## RPQ ADDENDUM

Addendum No.:	2	Date:	2/28/2025
Project No.:	CA166A	Project Title:	HGA Bldg 5 40-Year Recertification
RPQ No.:	CA166A	RPQ Due Date:	3/12/2025
Project Location:	HGA Bldg 5	Project Manager:	C. Cook

DRAWING NUMBER  
**G-003**

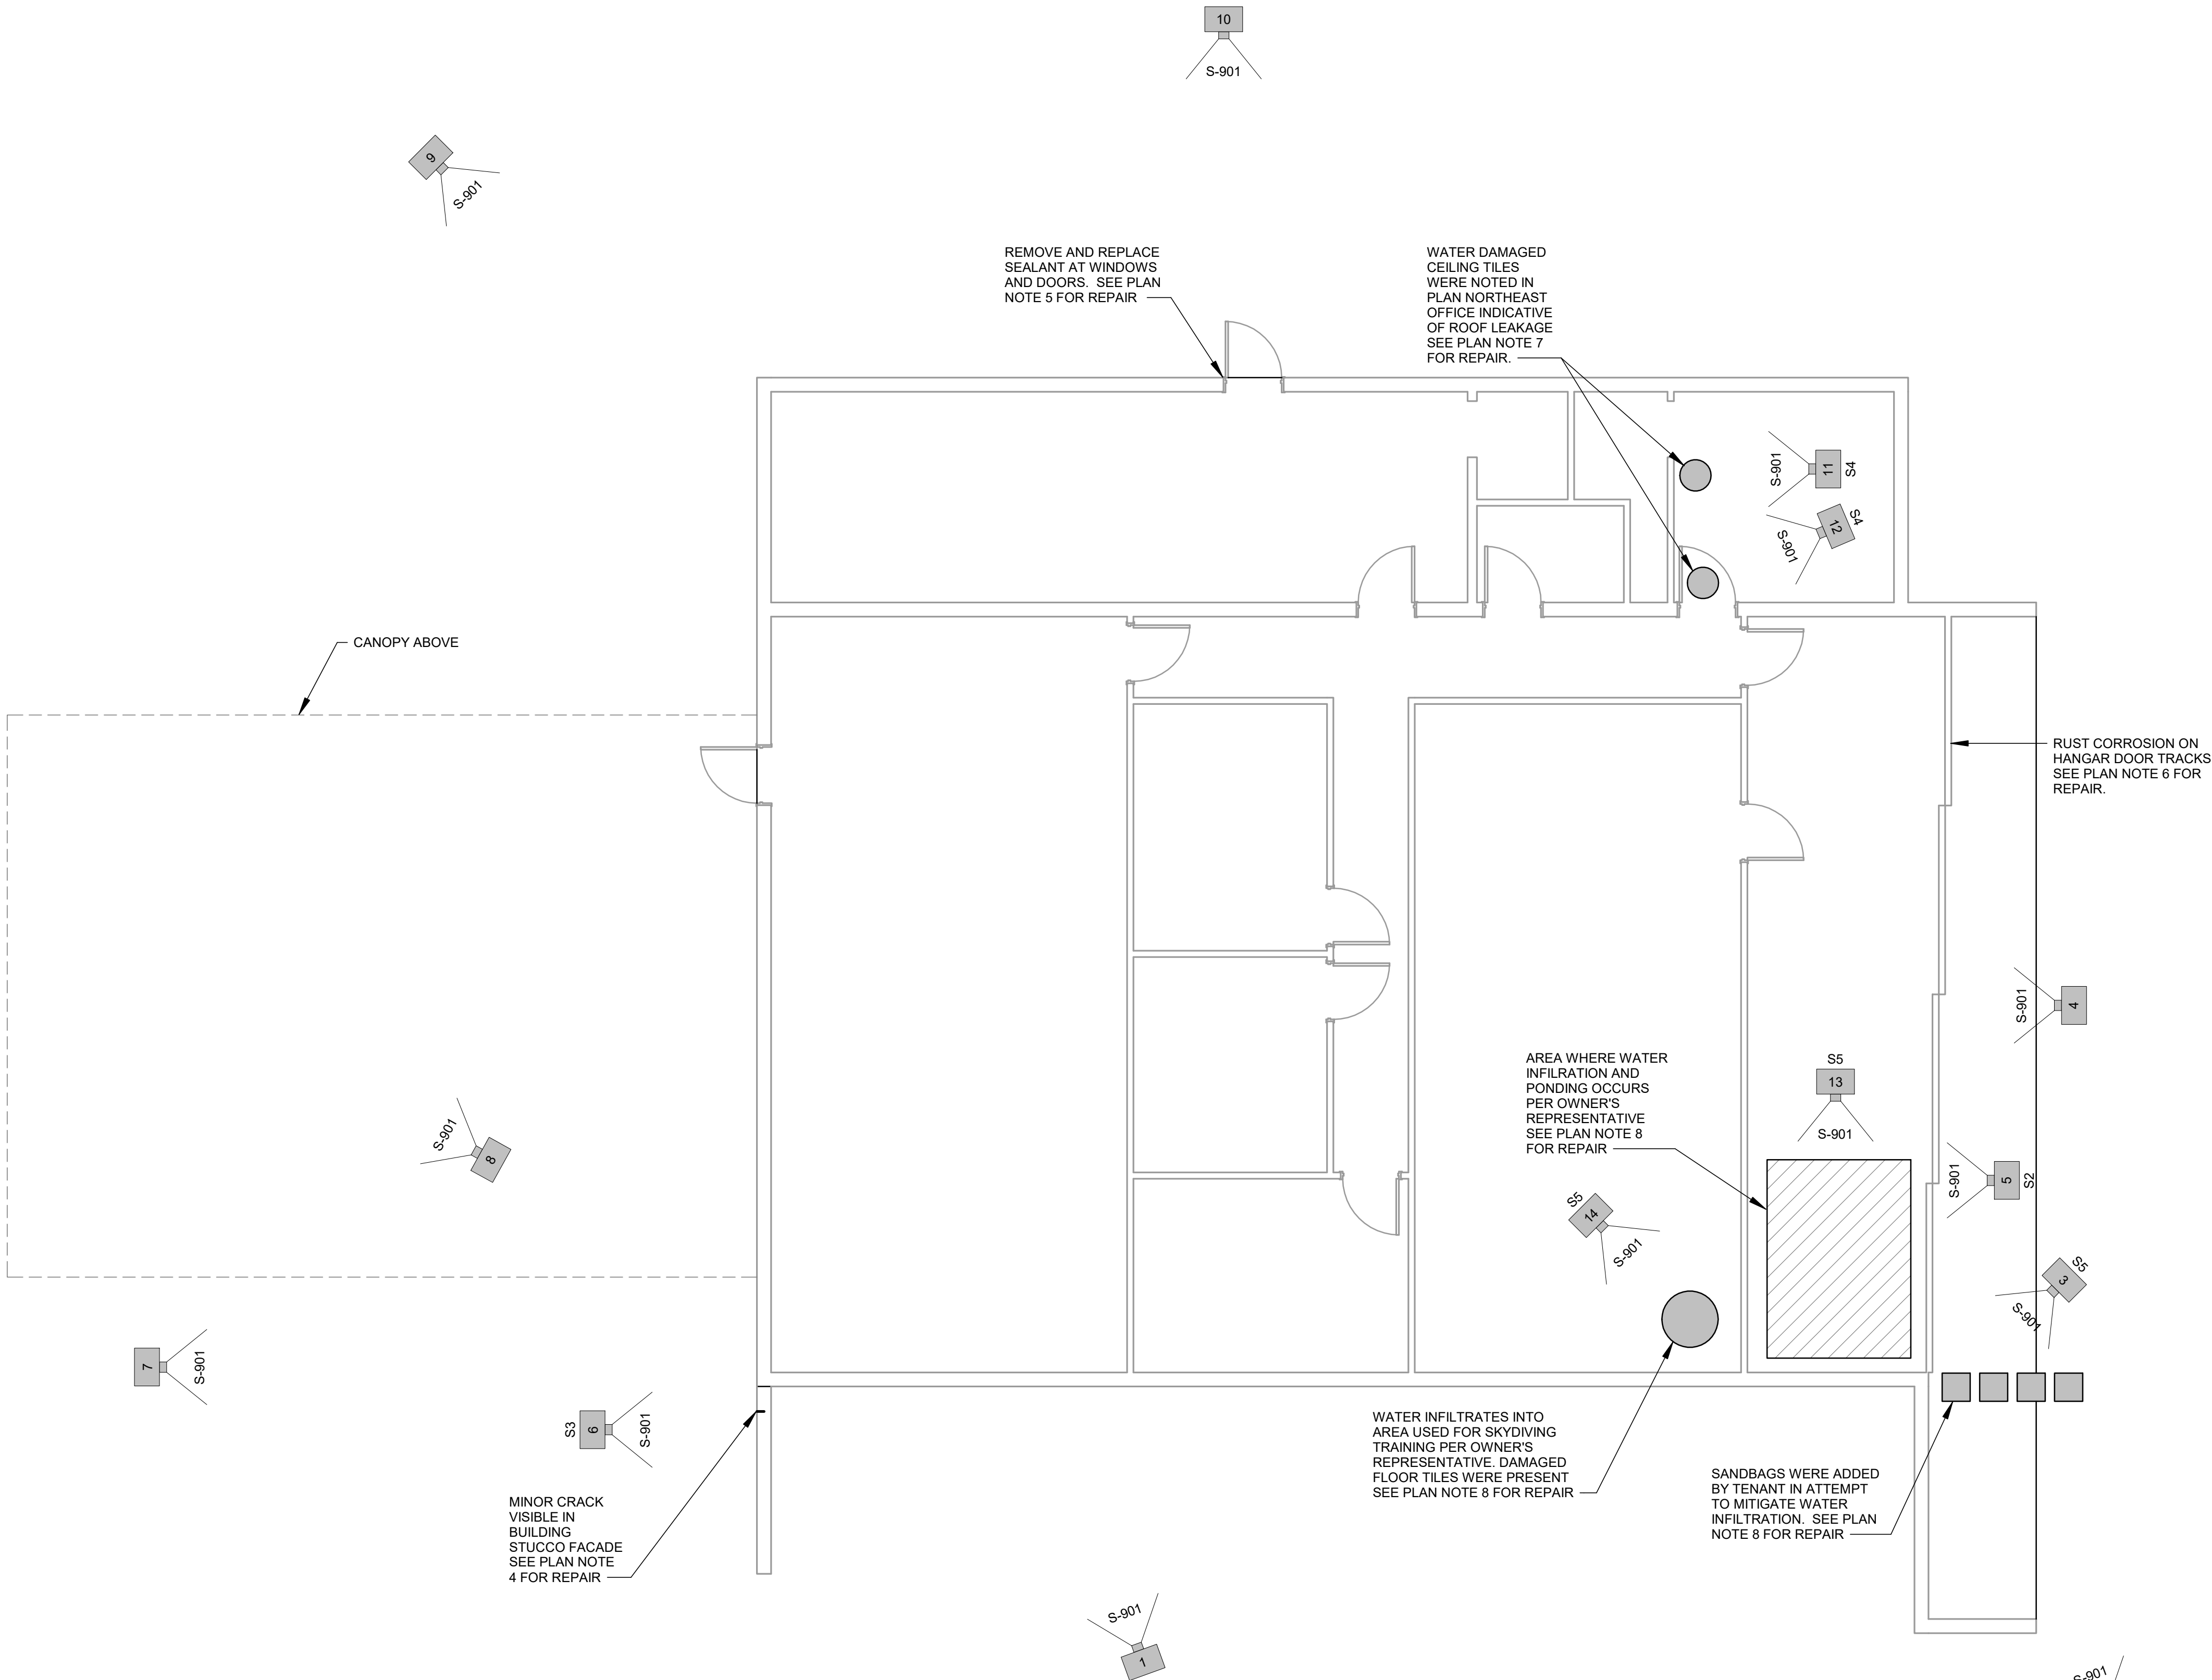
- Q.9 Will MDAD provide specifications for his project?
- A.9 Specifications were provided under Addendum #1.
- Q.10 Sheet G-0303 – Note 2. "LIGHTED BARRICADES SHOWN ARE FOR GRAPHIC PURPOSES ONLY. THE CONTRACTOR MUST DETERMINE THE QUANTITY OF LIGHTED BARRICADES REQUIRED TO COMPLETE THE WORK AS SHOWN AND MUST BE IN ACCORDANCE WITH CURRENT FAA ADVISORY CIRCULARS." For estimating purposes, can MDAD indicate a minimum quantity to consider?

- Q.11 Sheet G-003 – Note 3. "CONTRACTOR MUST HAVE AN APPROVED VACUUM TRUCK AVAILABLE ON SITE AT ALL TIMES. HYDRANTS TO FILL VACUUM TRUCK WILL BE AVAILABLE ON AIRPORT PROPERTY." Where are the locations of the available hydrants and the Vacuum Truck?

- A.11 This note is not applicable and shall be removed. Refer to the attached "Revised Sheet G-003 for Addendum #2".
- Q.12 Will MDAD provide a MOT plan?

- A.10 General notes on G-003 are included for general purpose only. Due to the minor deficiencies noted within the drawings, lighted barricades are not anticipated.

- A.12 Site access and proposed storage area has been included on G-003.
- Q.13 Sheet A-101 – New Work Keyed Notes 1 "NEW MODIFIED BITUMINOUS ROOFING SYSTEM OVER TAPERED INSULATION AS SPECIFIED. REFER TO PROJECT MANUAL SPECIFICATIONS." Please, provide specifications.
